**City of West Linn**  
**PRE-APPLICATION CONFERENCE MEETING**  
**SUMMARY NOTES**  
**September 3, 2009**

SUBJECT: Minor Remodel/Addition to House at 1892 4<sup>th</sup> Avenue in Willamette Historic District

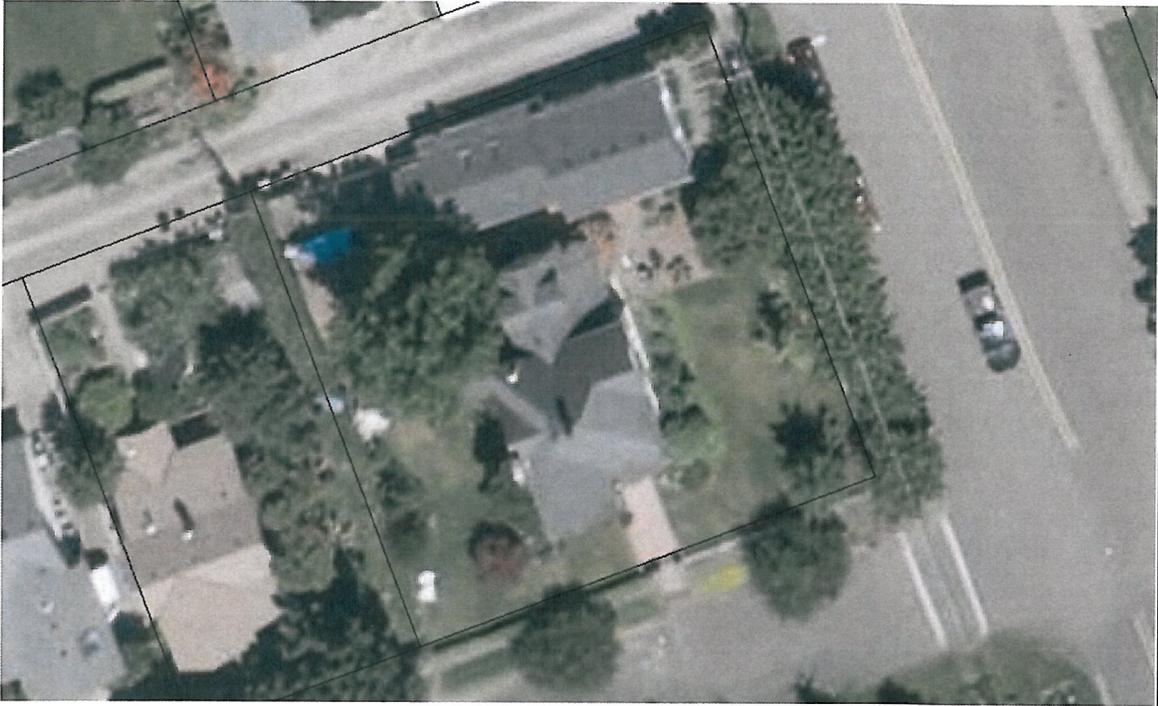
Charles Awalt expressed concern about the west elevation changes and, in particular, the roof pitch and design to match or defer to the existing pitches. Shed roof and flat roof options were also discussed. The applicant may rework that part of the plan. Concern about second floor window proportions was expressed. There is a significant tree to the west of the house and the applicant stated that it would be protected and saved through the remodeling process.
